9.3 Process Auxiliaries

The information in this section of the reference ABWR DCD, including all subsections, tables, and figures, is incorporated by reference with the following departures and supplements.

STD DEP Admin

Figure 9.3-10 Breathing Air System Flow Diagram

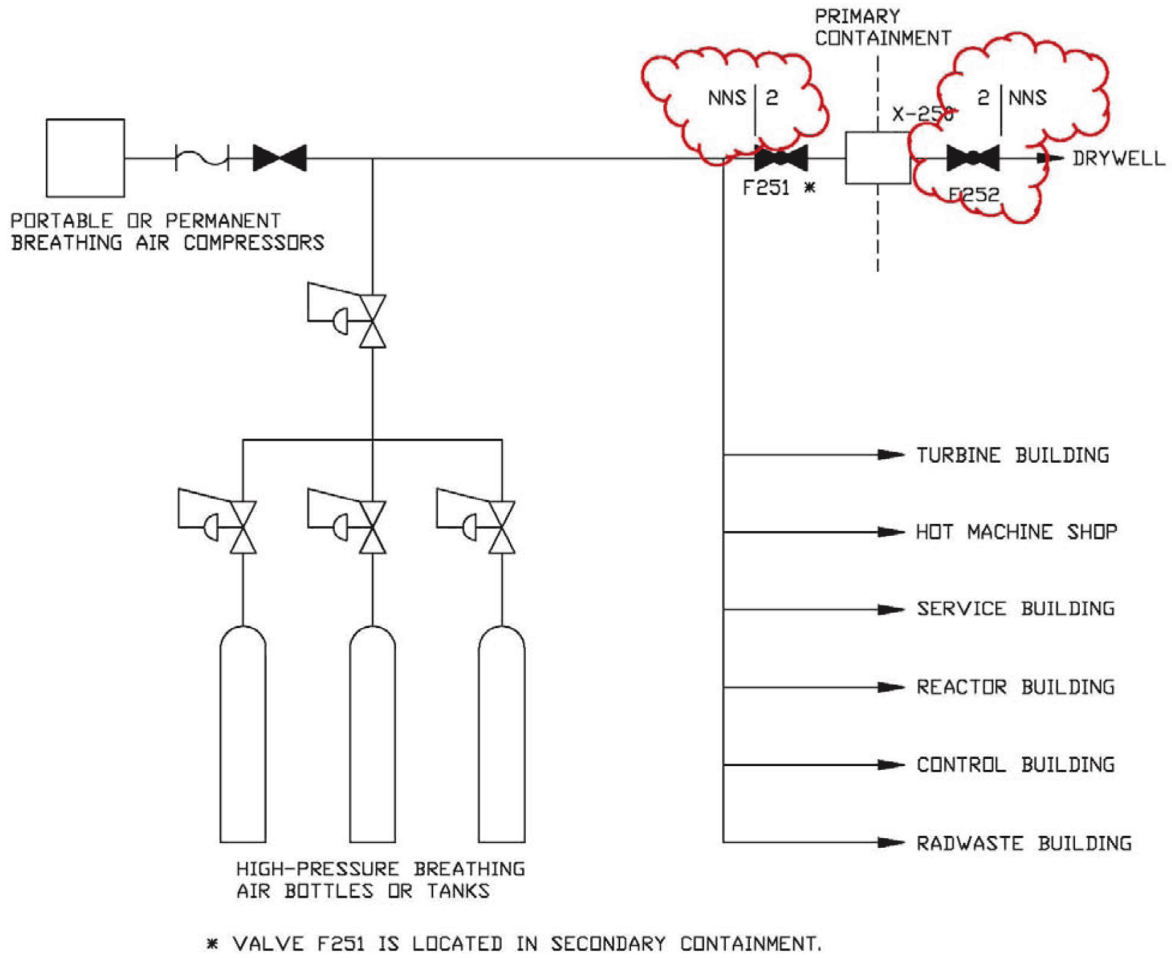
The SAS provides compressed air for tank sparging, filter/demineralizer backwashing, air-operated tools and other services requiring air of lower quality than that provided by the IAS. ~~Breathing air requirements are provided by the SAS.~~ The Breathing Air System (BAS) is discussed in Subsection 9.3.7.6.

The BAS is sized to provide 100% of the peak air consumption using the bottled breathing air supply and a portable permanent breathing air compressor supply system, as needed. The compressor(s) will be of the oil-less, breathing air type.

The BAS flow diagram is shown in Figure 9.3-10.

<u>Pressure (design of BAS)</u>	<u>689 kPaG</u>
<u>Pressure (design of self-contained breathing apparatus charging)</u>	<u>17.23 MPaG</u>
<u>ANSI Compressed Gas Association (CGA) 7.1-1997, "Commodity Specification for Air"</u>	<u>Air Quality Grade D</u>

Figure 9.3-12 Non-Radioactive Drainage System

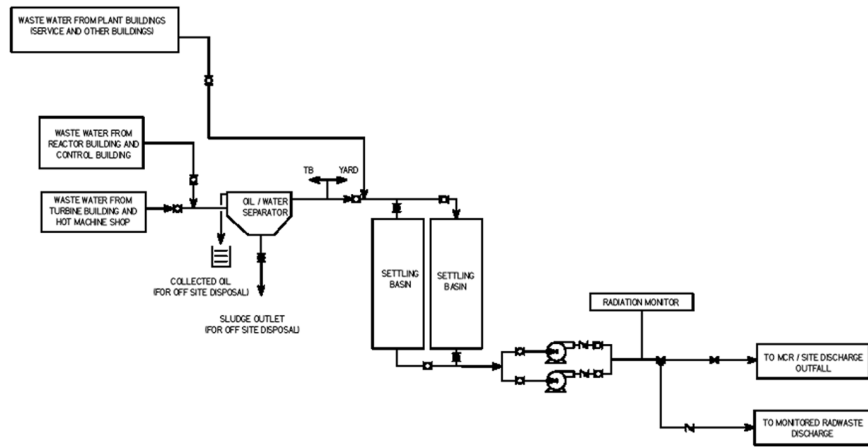
The design of the continuation of the non-radioactive drain system from the ABWR Standard Plant Buildings to the site discharge outfall is provided in Figure 9.3-12 and is discussed in this subsection.

discharged to the Main Cooling Reservoir through permitted outfall(s). If radioactivity levels exceed the limits for discharge, the flow from the non-radioactive drains has the capability to be diverted to the radioactive effluent portion of the radwaste system. Normally, if low levels of radioactivity are detected, it is quantified and discharged via the normal outfall. Higher levels of radioactivity may require a permitted "batch" discharge via the radwaste effluent radiation monitor. The non-radioactive drainage system is illustrated in Figure 9.3-12.
